Jerrod Meier
Director
Electric Compliance

300 Lakeside Drive
Oakland, CA 94612

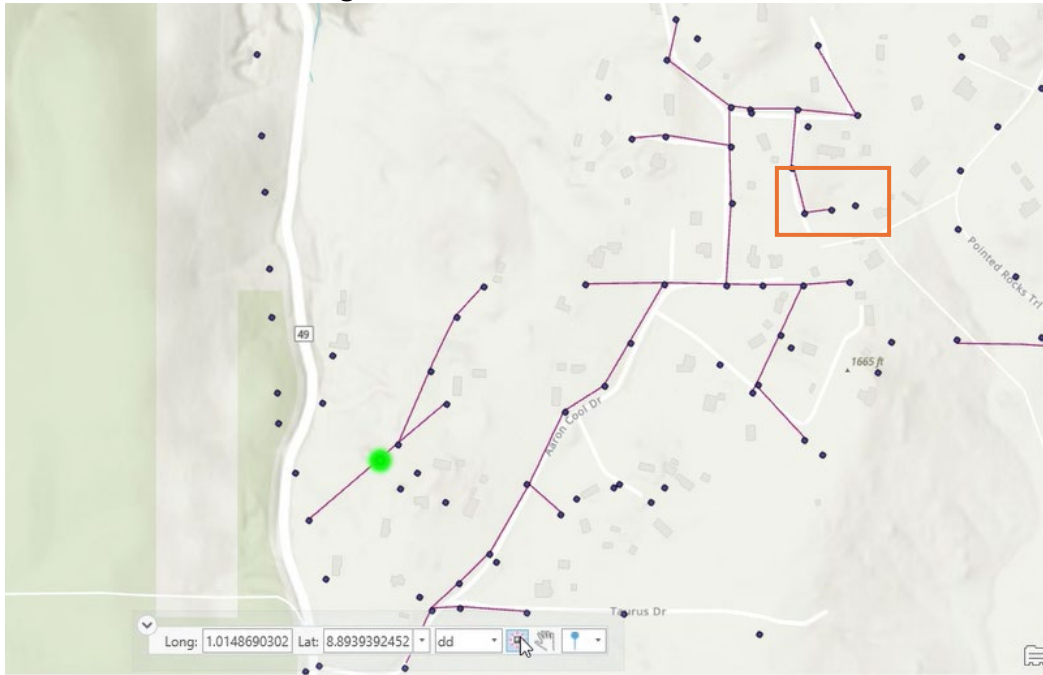
Image 2: GH ID 35293673 Redlined As-Built

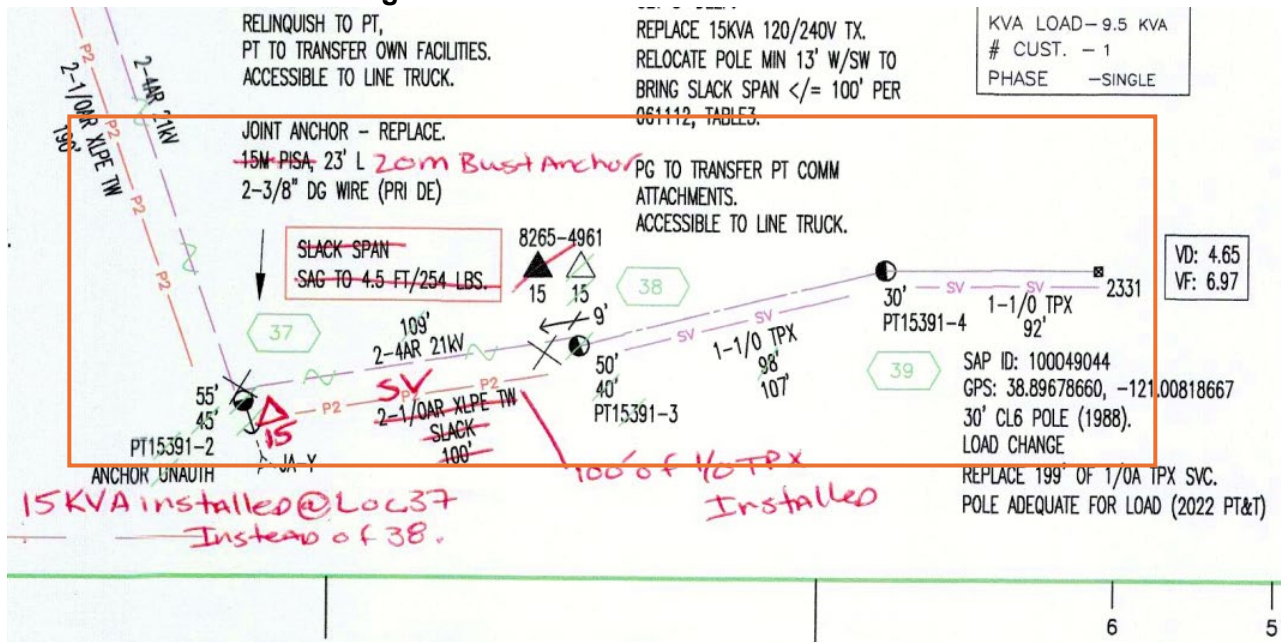
Image 2 is the redlined As-Built drawing that depicts the design change of the span east of pole 121530972 (Loc 37) from a primary line to a secondary line. Loc 37 is also where the transformer was installed.
